Regional Haze

State Implementation Plan Supplement

April 2012

Appendix 4: Public Comments and Response

Figure 1 – Comparison of Emissions Under CSAPR and BART for BART-subject Units in Minnesota

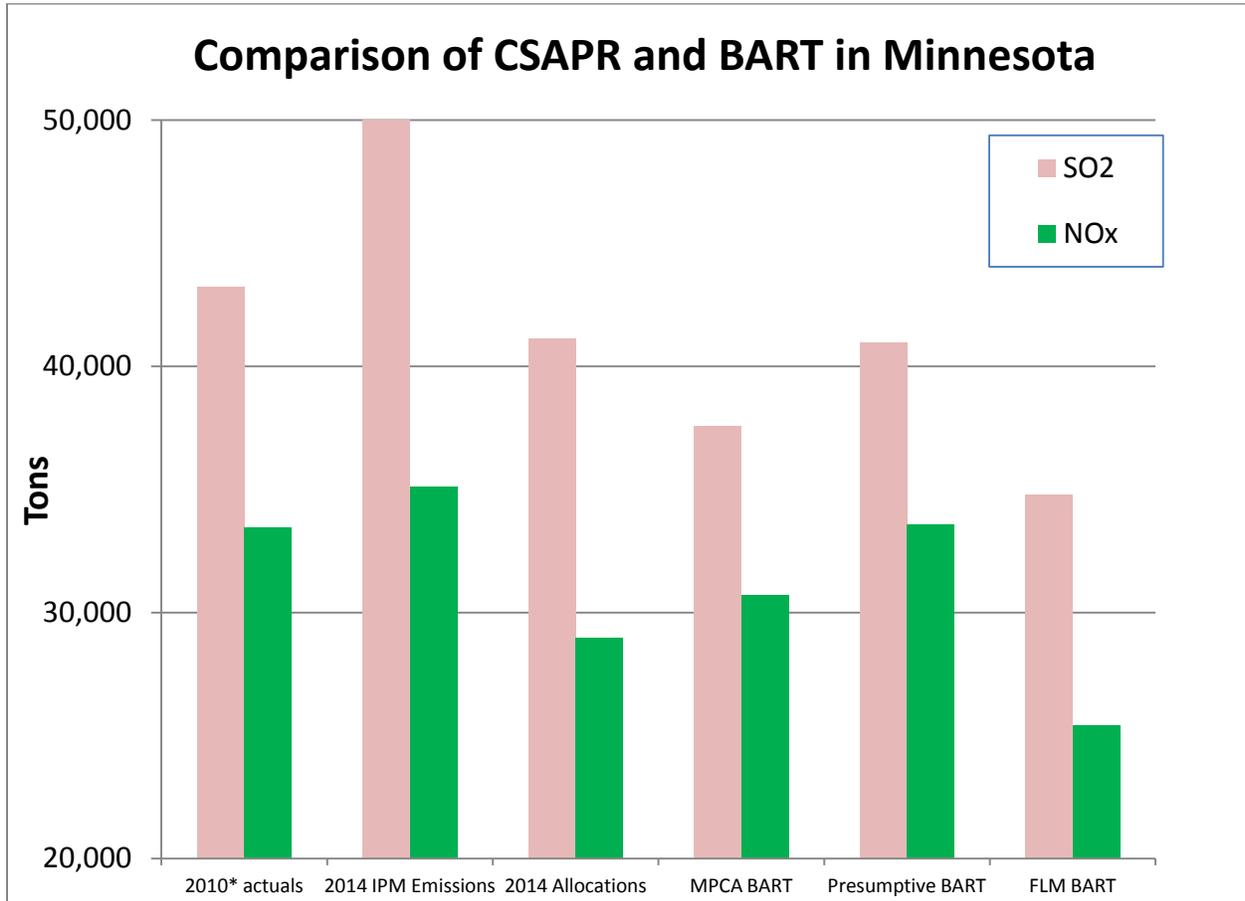
Instead we attempted to compare source-specific EGU BART to CSAPR for Minnesota in Figure 1. The graph shows that the IPM prediction of the affect of CSAPR in 2014 (i.e. “2014 IPM Emissions”) is an increase in emissions over current (2010) actual emissions. In addition CSAPR is well above both what was proposed as source-specific BART by MPCA and what we and the other Federal Land Managers (FLMs) proposed as source-specific BART. Without any other information specific to Minnesota we find source-specific BART to be far superior to CSAPR.

We strongly encourage the MPCA to reject using CSAPR as a replacement and believe the source-specific BART limit approach should be maintained. The MPCA should also re-evaluate the limits determined for Xcel Energy’s Sherburne County and Northshore Mining’s Power House and consider the comments made by EPA (in letters dated September 3, 2009 and June 6, 2011) and ourselves (in our 2009 letters). The recent stay of CSAPR puts its future in doubt. The regional haze plans are more than four years overdue already. Please do not delay the plan and visibility improvement any longer by keeping Minnesota’s Regional Haze Plan tied to any of the federal trading rules. Please use source-specific BART limits in this plan.

Figure 2 – Emissions of NO_x and SO₂ Under Various BART Options for United Taconite

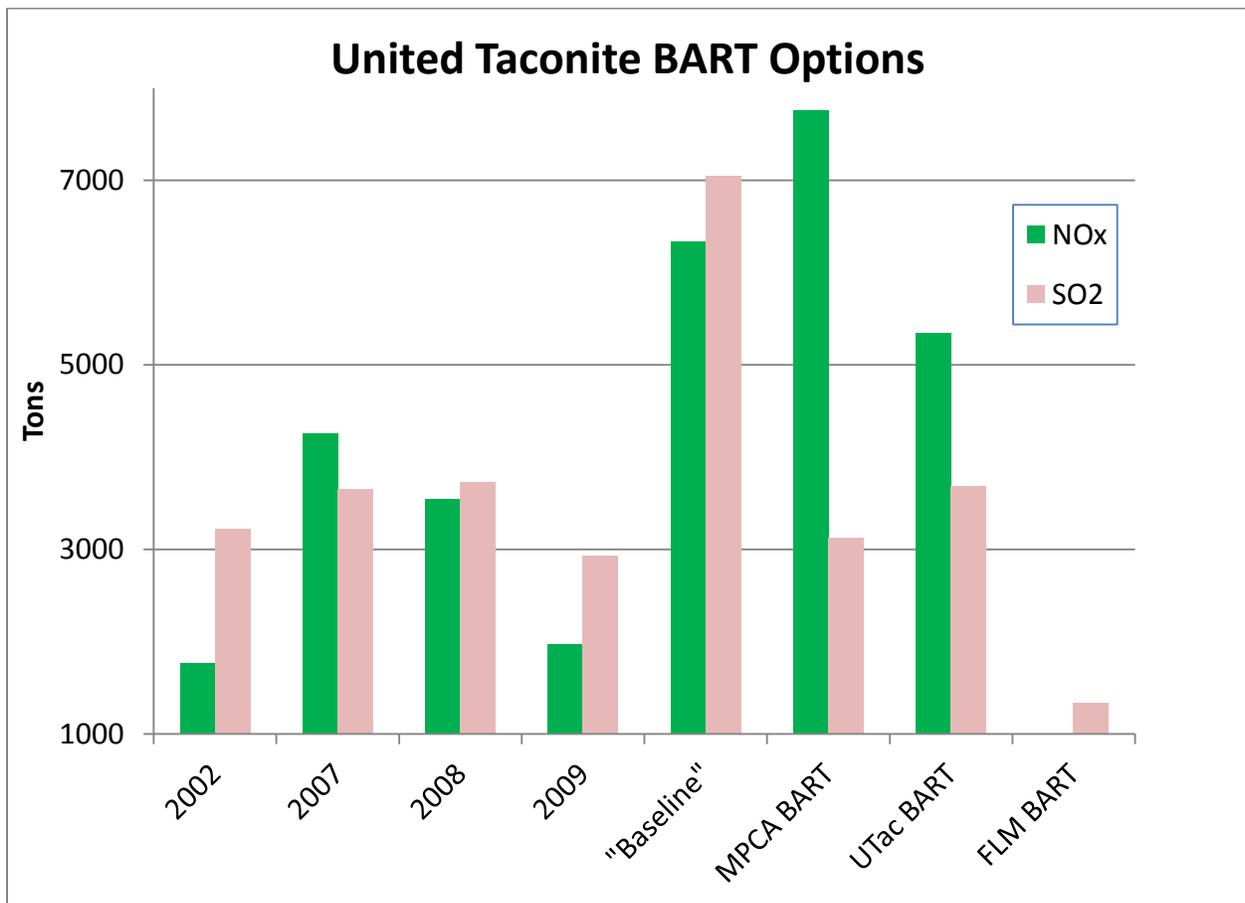
The combination of these factors results in paper emission reductions. The following graph illustrates the point. It also includes actual emissions for 2002, 2007, 2008, and 2009.

Figure 2 shows that all the BART proposals are unconstraining except for our BART proposal (which is based on the original BART determination for Line 1 in combination with a limit of 0.68 lb/MMBtu for Line 2). Since a proper BART analysis was not submitted for NO_x, we have no information from which to propose a BART limit for NO_x. Therefore no value was included in Figure 2 under FLM BART.

In summary please submit a full BART analysis for coal-fired Line 1 and correct the NO_x BART analysis for Line 2. The BART proposal in the Supplement does not include a consideration of the Clean Air Act factors for BART. It is irrelevant that the emission limit chosen is less than both an inflated baseline value, and an inflated, initial BART determination. The emission limit should be selected as an outcome of an analysis of the Clean Air Act factors.

Figure 2. Sherco Plant Site Photo

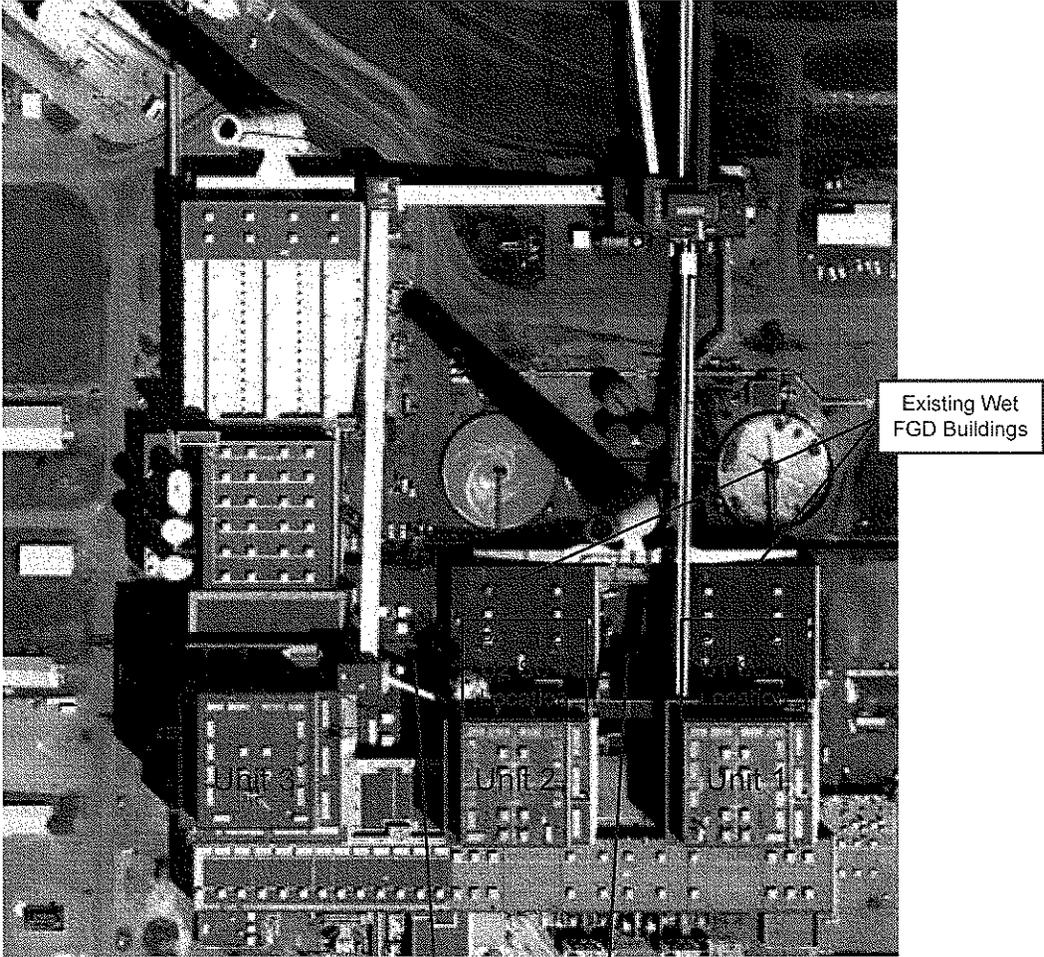
In contrast to the King Plant, the Sherco Plant has three units in close proximity to one another which will result in an increased level of retrofit difficulty. Figure 1 shows the three Sherco units in alignment, which clearly shows the difficulty in locating the equipment needed to construct SCRs on units 1 and 2. It would be especially difficult to locate cranes for site construction for Unit 2. Neither the Control Cost Manual nor the CueCost Workbook adequately account for these site-specific costs.

Limited space
for construction
cranes

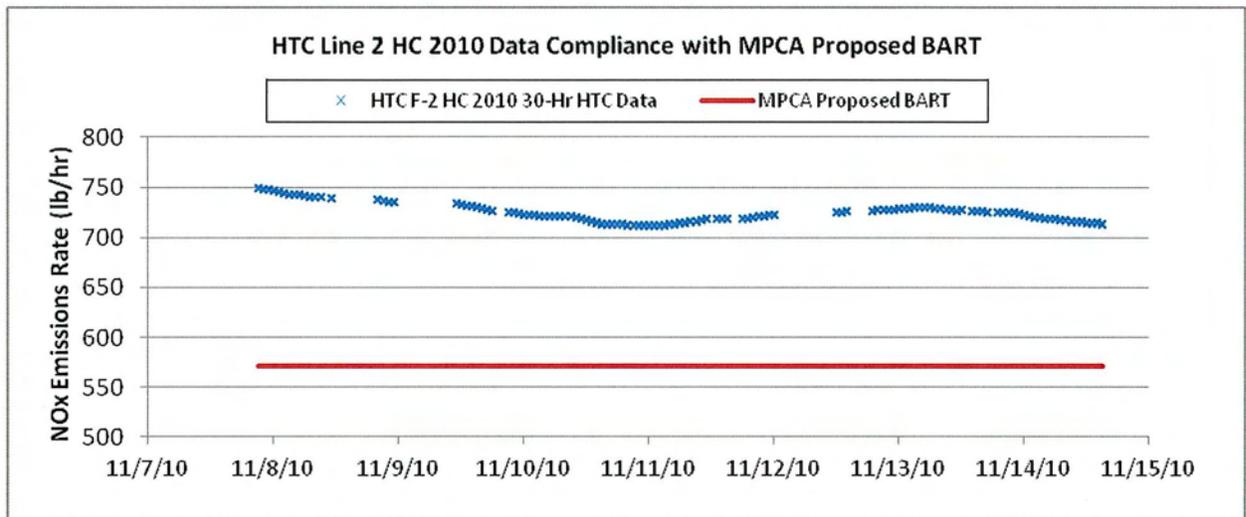
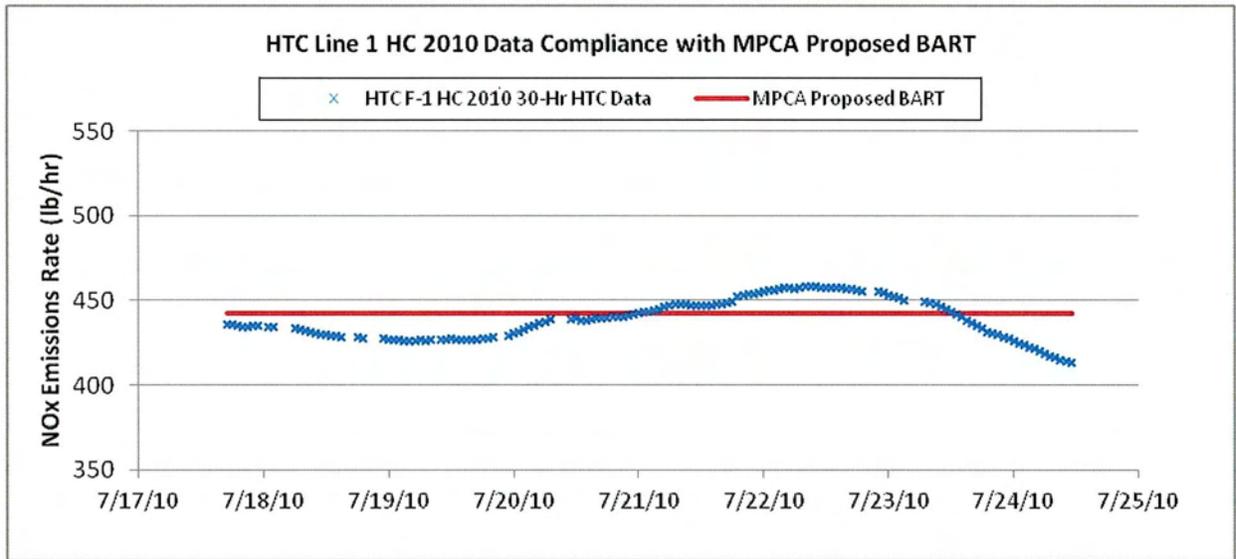
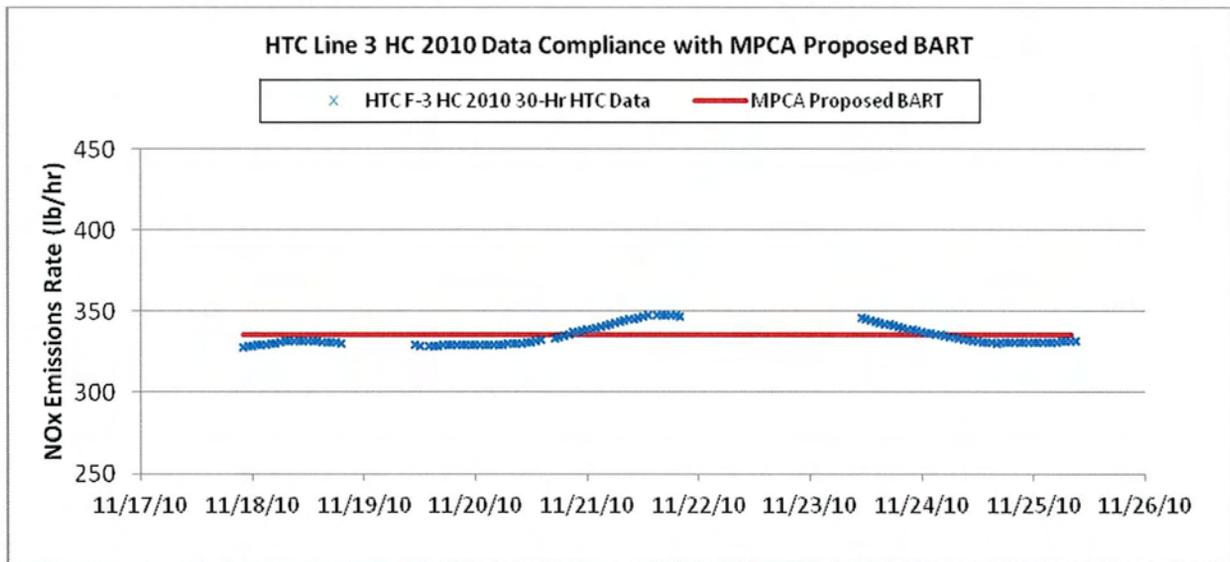
In fact, available emissions data already demonstrates inability for all three of Hibbing Taconite's furnace lines to reliably meet the limits proposed as part of the SIP Supplement. As an example, a review of emissions data collected during 2010, with a 30-day rolling average applied, indicates the following:

- HTC Line 1 would have emissions in excess of the proposed limit 39% of the time during the duration of the test.
- HTC Line 2 would have emissions in excess of the proposed limit 100% of the time during the duration of the test.
- HTC Line 3 would have emissions in excess of the proposed limit 29% of the time during the duration of the test.

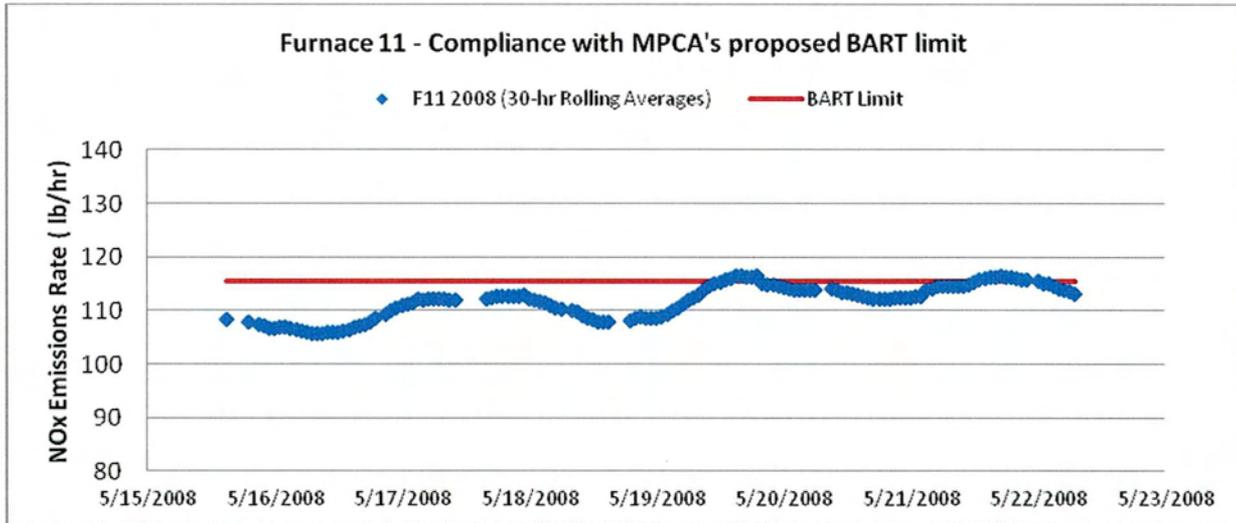
In fact, available emissions data already demonstrates inability for Northshore to reliably meet the limits proposed as part of the SIP Supplement. As an example, a review of emissions data collected during

2008, with a 30-day rolling average applied, indicates that Northshore's Furnace 11 would have emissions in excess of the proposed limit 13% of the time during the duration of the test.

Figure 1 – Drawing of Minntac Grate-Kiln Furnace

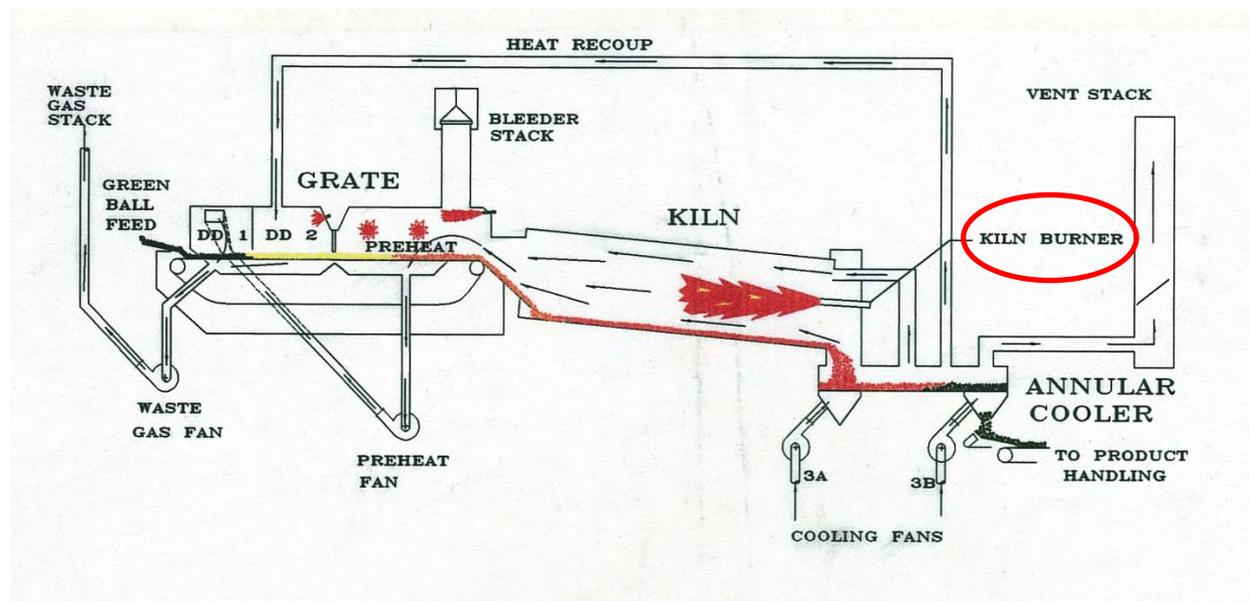
The replacement of the main kiln burner at Minntac is not a “trial” or “pilot test.” Trials or pilot tests are often done on a small slip stream of exhaust gas drawn out of boiler or furnace that can be easily stopped. In this case the entire burner is replaced during the annual maintenance outage. As you can see in Figure 1 - the main kiln burner is a large, integral part of the furnace and replacing it is not easily undone and should not be characterized as a “pilot test” or “trial”.

Figure 2 – MPCA Taconite BART Emissions and Current Annual Actual Emissions

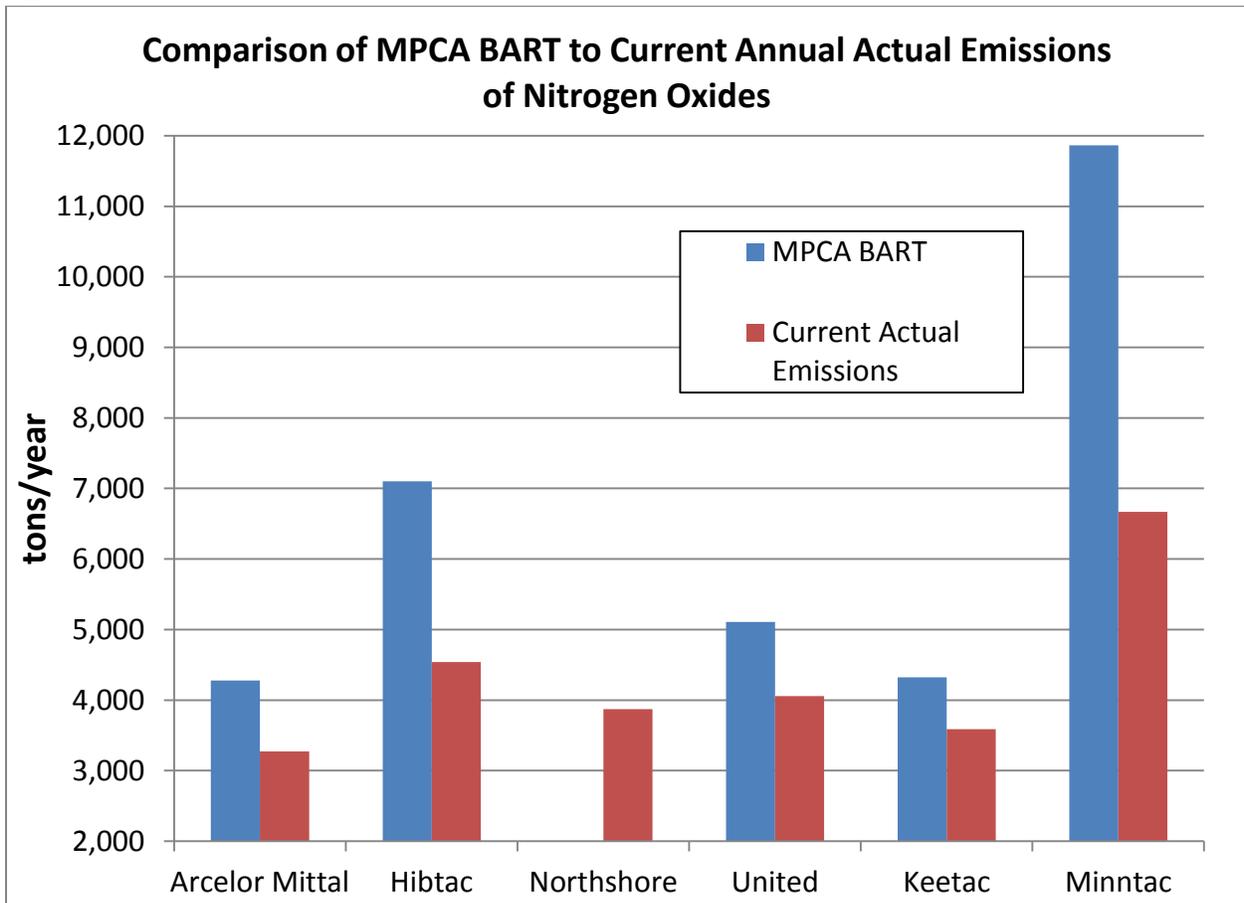
USFS perspective: The current emissions from the plants (2010 for all except Hibbing Taconite which we used 2008 since 2010 was a low production year for that plant) were compared to the proposed BART limits assuming a 2 week annual maintenance outage at each plant. It can be seen in Figure 2 that the proposed BART limits are indeed above current actual emissions.

Figure 3 – Taconite Industry Emission Rate Comparison

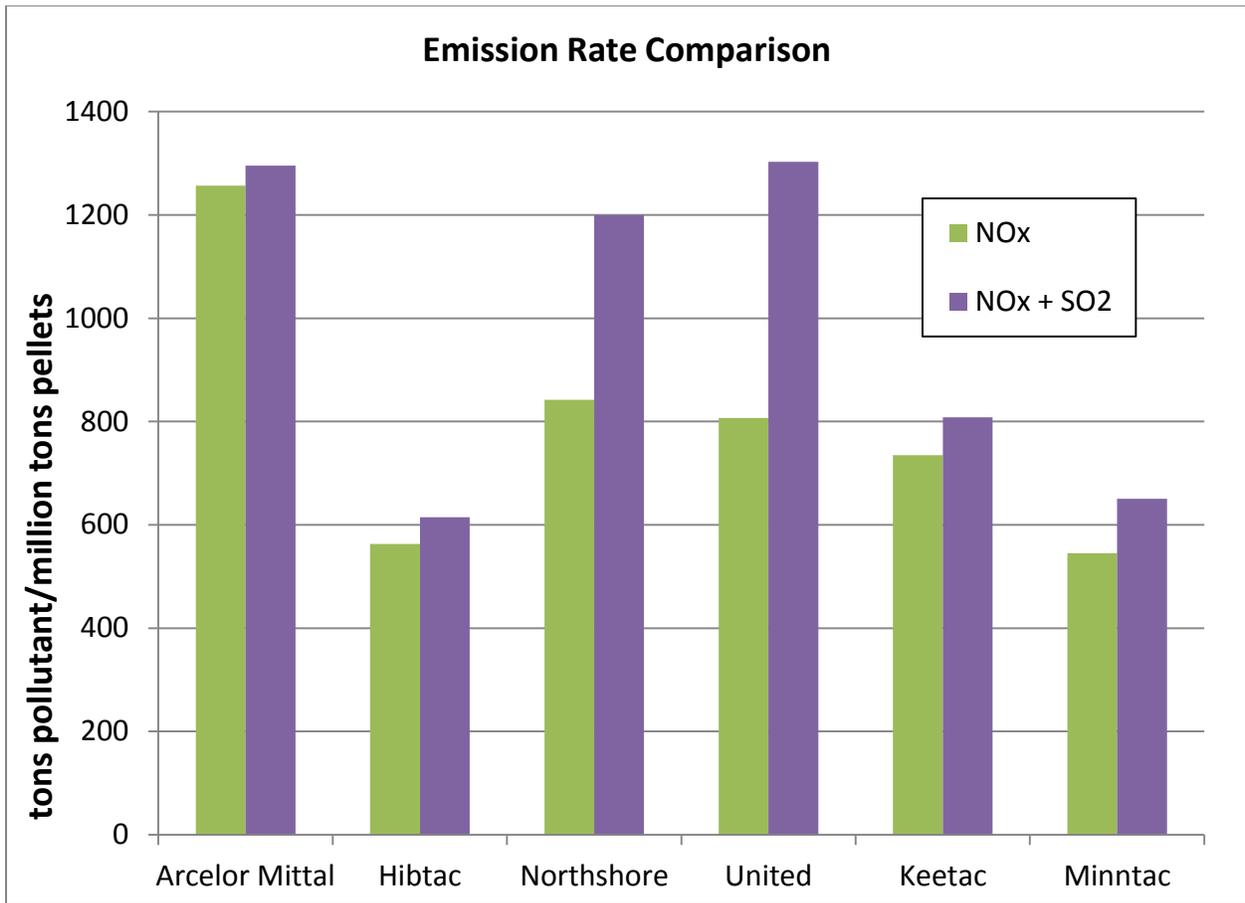
Since the plants have different levels of production we were interested in the emission level per ton of production to better aid in comparing the facilities (Figure 3). In addition to nitrogen oxides, we also added a set of bars that show sulfur dioxide plus nitrogen oxide emissions since the burning of coal can serve to reduce nitrogen oxide emissions, but will also increase sulfur dioxide emissions. The graph shows that some facilities emit twice as much haze-causing pollution as others on a per ton basis. As the US Steel facilities (Minntac and Keetac) continue to add LNBS and sulfur controls, their emissions will continue to decrease. Why can't the other plants reduce their emissions to similar levels?
